## MEMORANDUM ADDENDUM #2

**TO:** All Bidders  
**FROM:** Tracey Arena  
**DATE:** April 28, 2022  
**RE:** Village of Ardsley Contract No. VOA1811 New Public Works Facility

## **ADDENDUM NO. 2 dated April 28, 2022**

#### **Contract No. VOA1811 New Public Works Facility**

① SHOP/STORAGE 119 ROOF OVERHANG  
 3/4" = 1'-0"

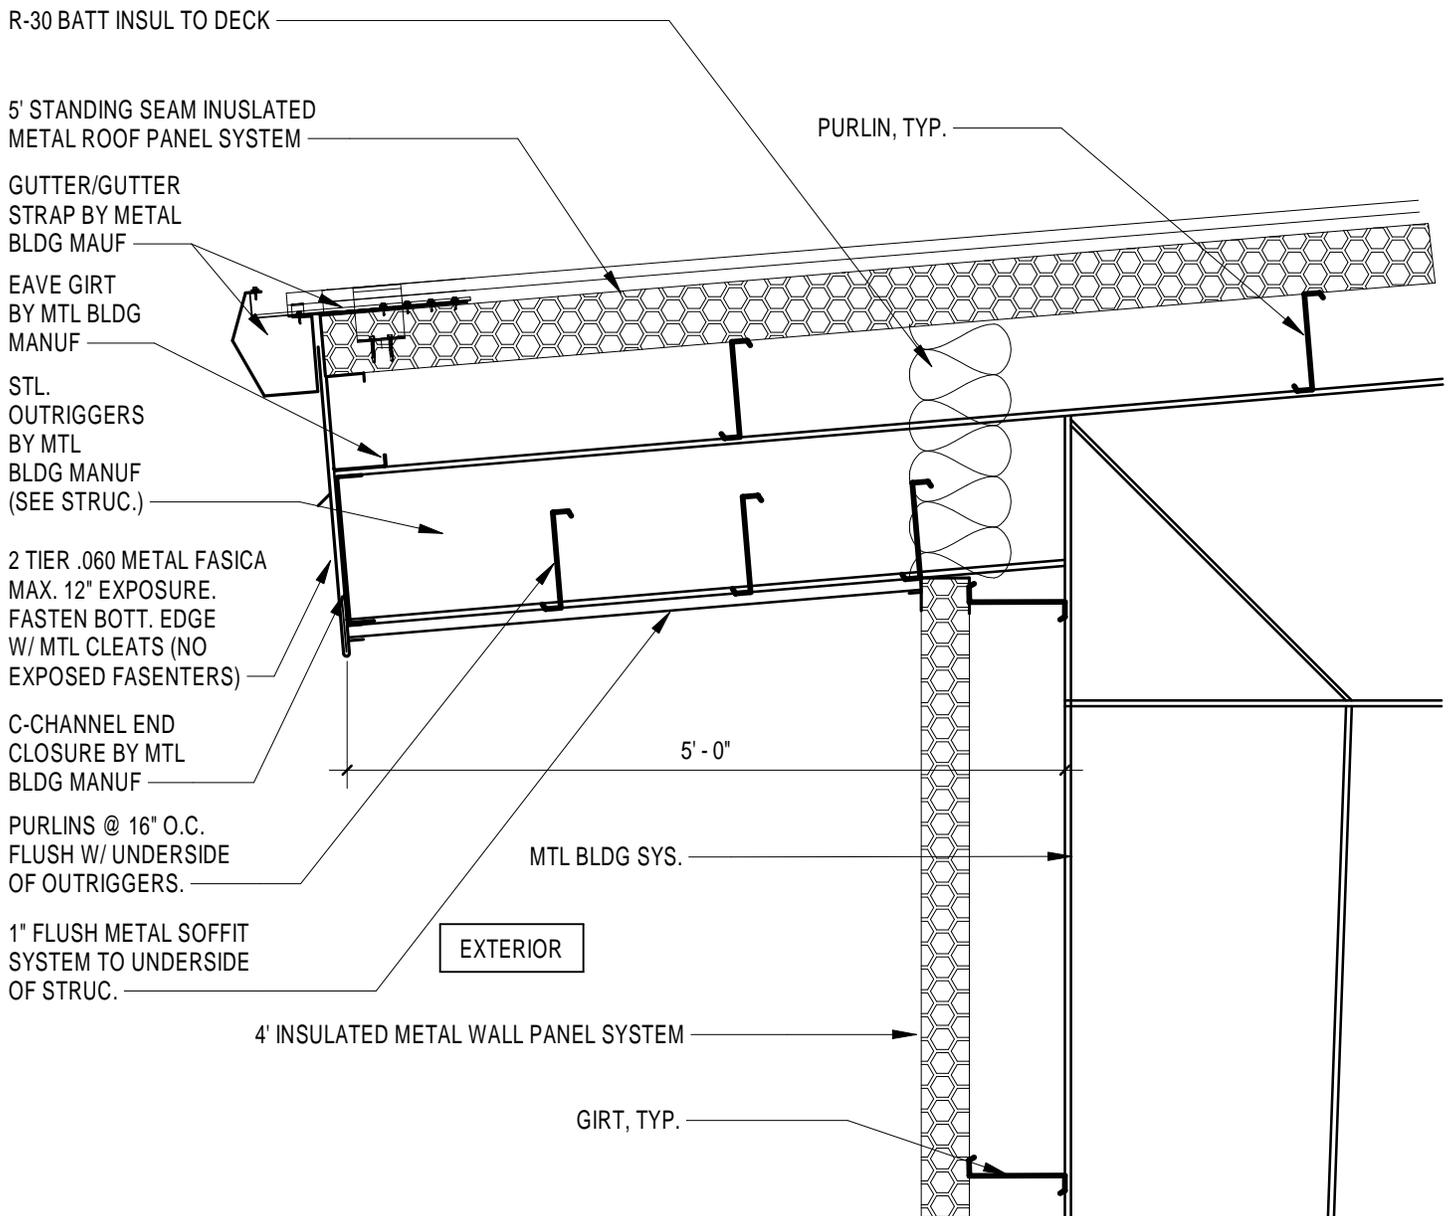
- SK-1 detail for clarification of the south roof overhang at the Shop/Storage 119 deduct alternate #3.
- Reissue Drawing S-002
- Reissue Drawing E102
- Reissue Drawing E201
- Reissue Drawing E202
- Reissue Drawing E203
- Reissue Drawing E204
- Reissue Drawing E502
- Reissue Drawing E503
- Reissue Drawing E704

**ENLARGED ELECTRICAL ROOM**

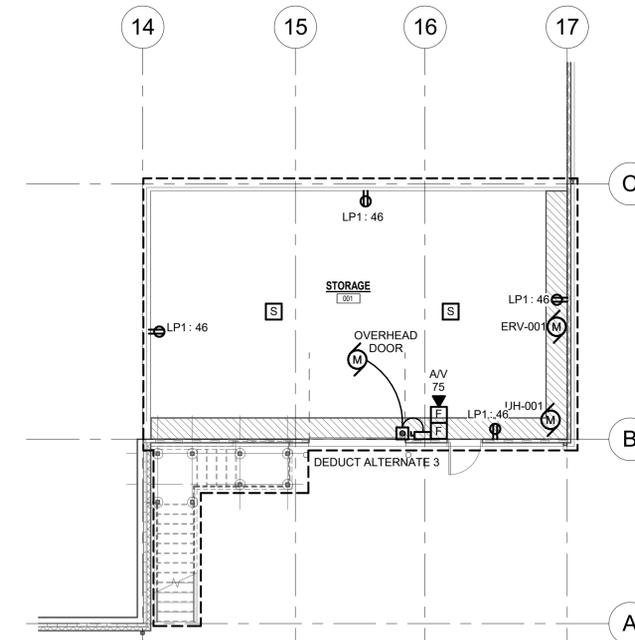
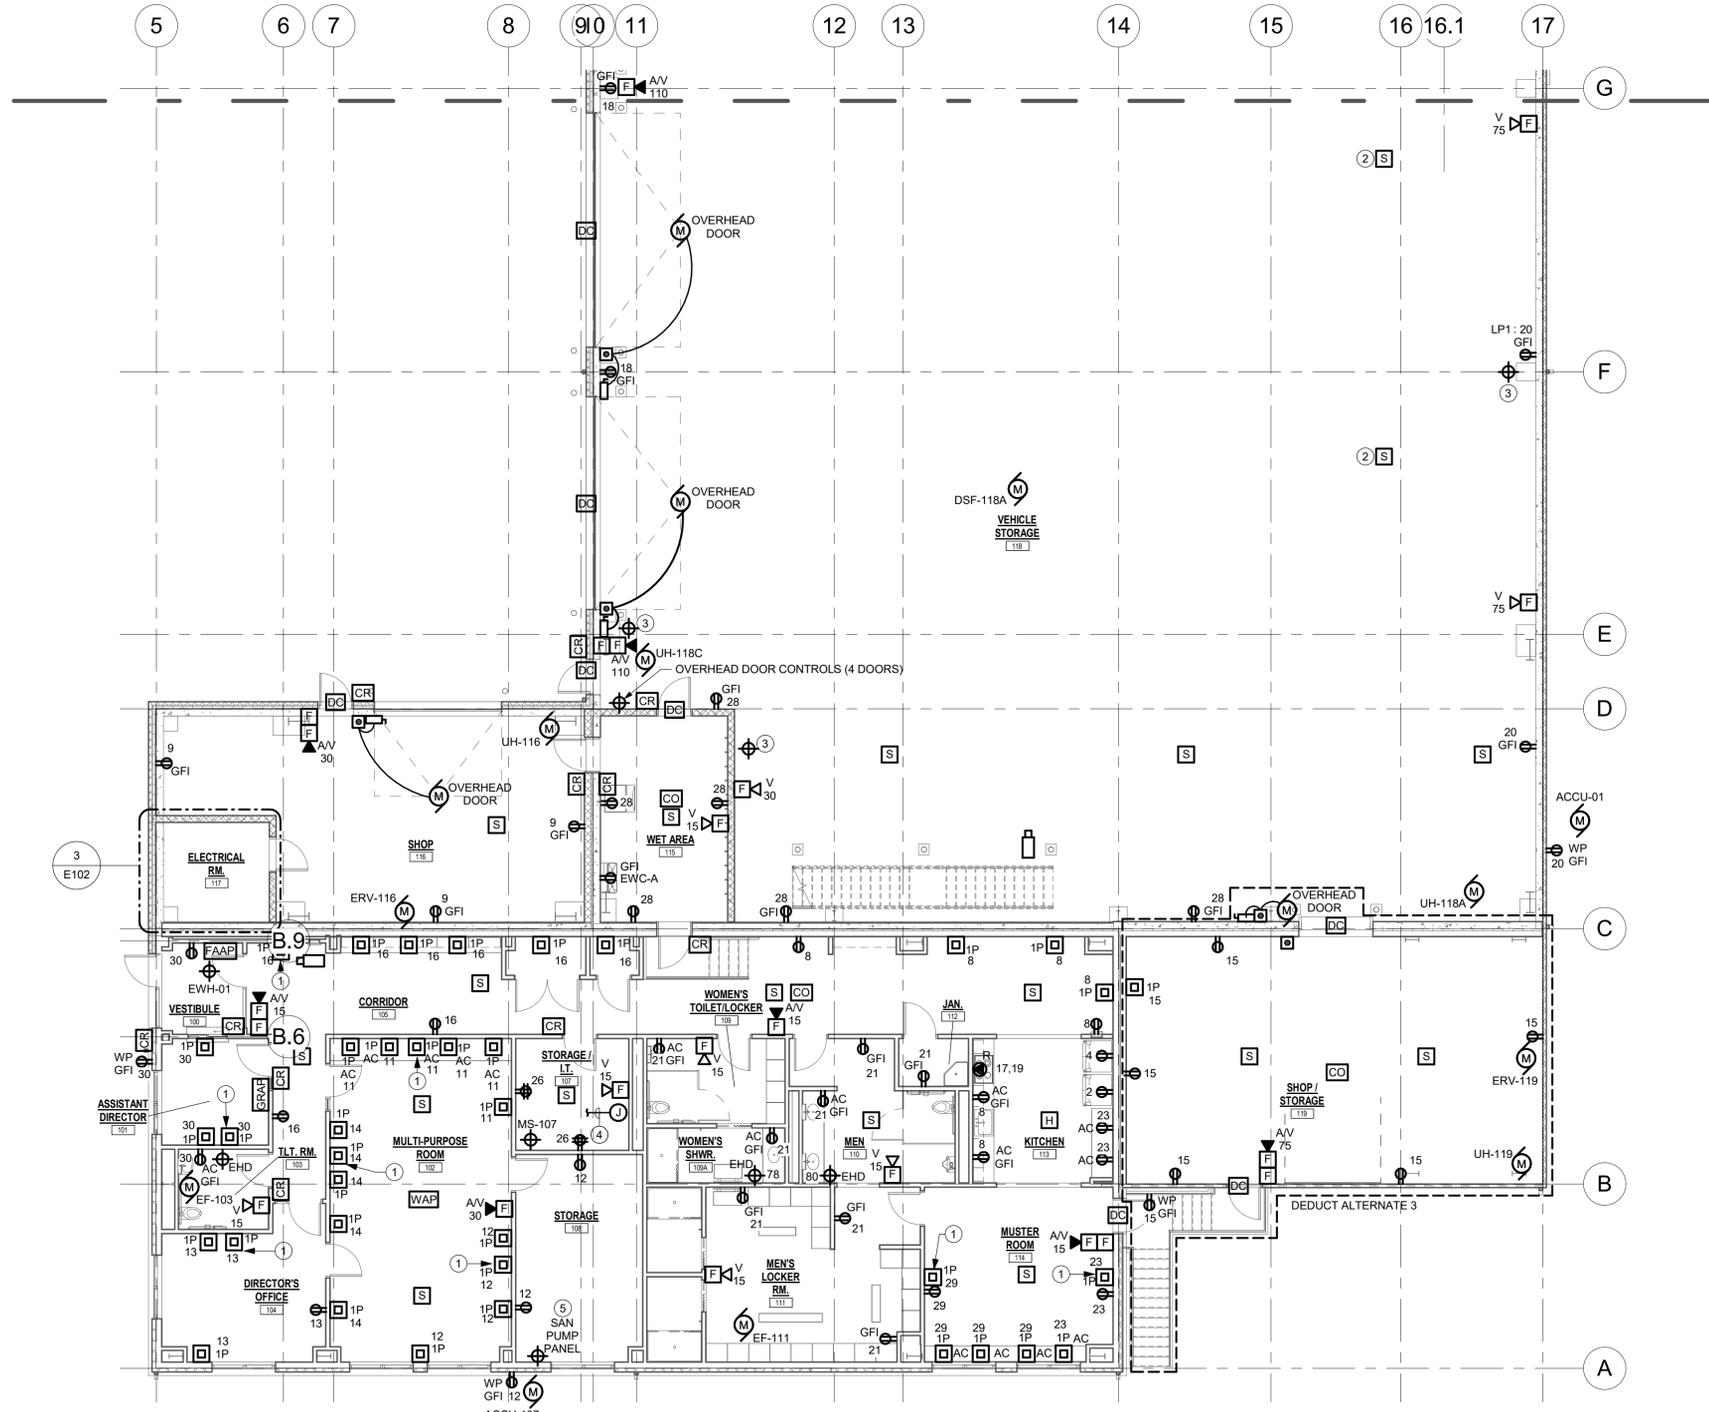
39. **QUESTION:** Drawing E102 Addendum #1, there is no Fire Alarm Control Panel shown. Please advise exact location of the Fire Alarm Control Panel.

**RESPONSE:** Fire Alarm Control panel was shown in Electrical Room 117 in the original bid documents, but disappeared in Addendum #1. Addendum #2 will add the FACP back to room 117.

6 STRUCTURAL STEEL GROUNDING DETAIL  
 NTS 4/ E502

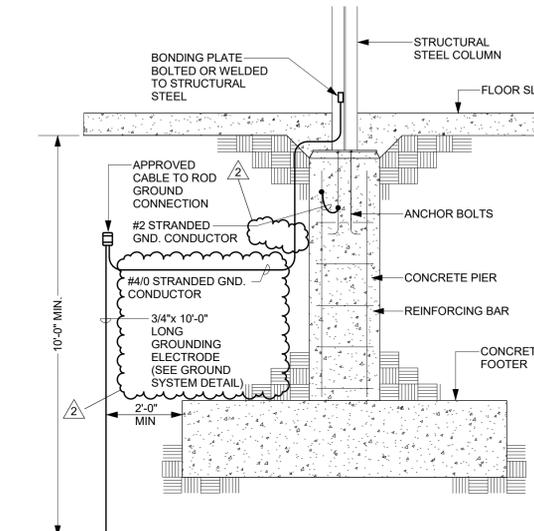
33. **QUESTION:** Drawing E502 detail 6. Is this detail applicable to only 1 structural steel column? If not, please advise how many structural steel columns it applies to. We need exact quantity.

**RESPONSE:** Detail 6 is only applicable to 1 location and corresponds to detail 4/E502. Details to be clarified in Addendum #2.

**FIRE ALARM BLOCK DIAGRAM**

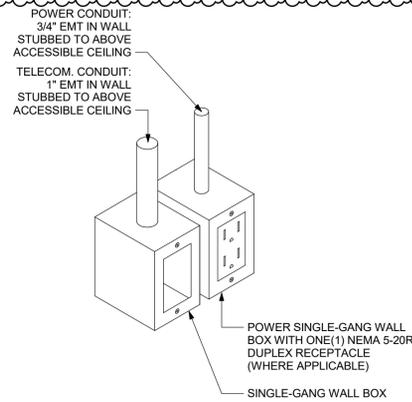
38. **QUESTION:** There is not Fire Alarm Riser diagram given. Will a detailed Fire Alarm Diagram be forthcoming?

**RESPONSE:** Fire alarm block diagram will be added in Addendum #2.
